SUNDRY NOTICES AND REPORTS ON WELLS

**Garcia Gas Com B #1E**

**MV Recompletion Procedure**

New Mexico Oil Conservation Division  
Conditions of Approval

**Well Name: GARCIA GAS COM B #1E**

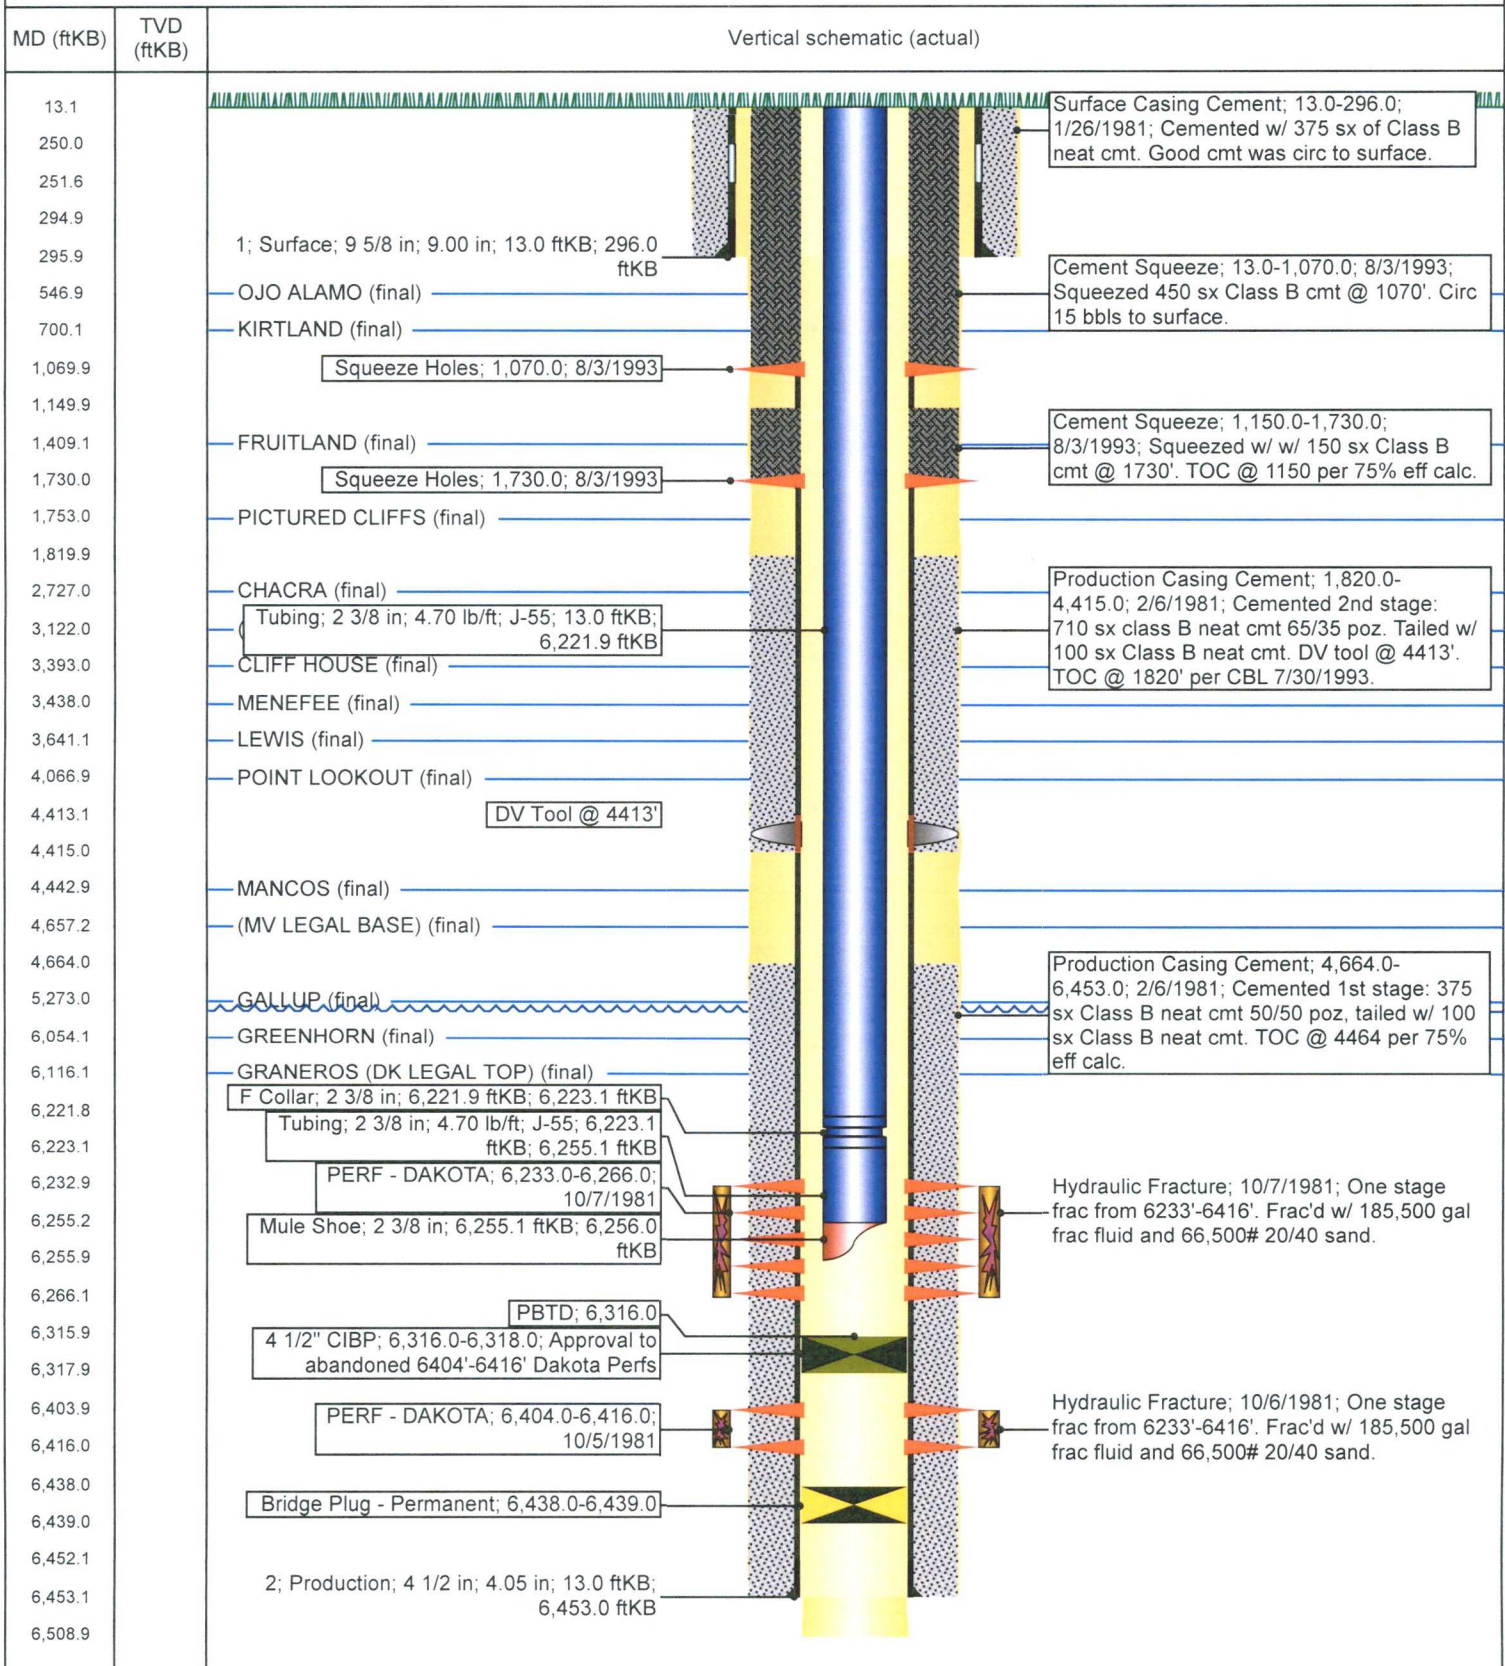
- Notify the OCD 24hrs prior to beginning operations.
- Hold C-104 for NSL
- Set cast iron bridge plug (CIBP) inside of cemented casing and at least 500' below the bottom of the proposed perforations. To show adequate formation/cement isolation.
- Perform and submit a cement bond log (CBL) to the OCD for review and approval prior to perforating the formation. **Note: the 7/30/1993 CBL referenced would not show the cement top from the first stage or isolation at the bottom of the proposed perforations. Also, the 7/30/1993 CBL referenced was not filed with the OCD.**
- If needed, submit proposed remediation plan to the OCD for review and approval prior to starting remediation.
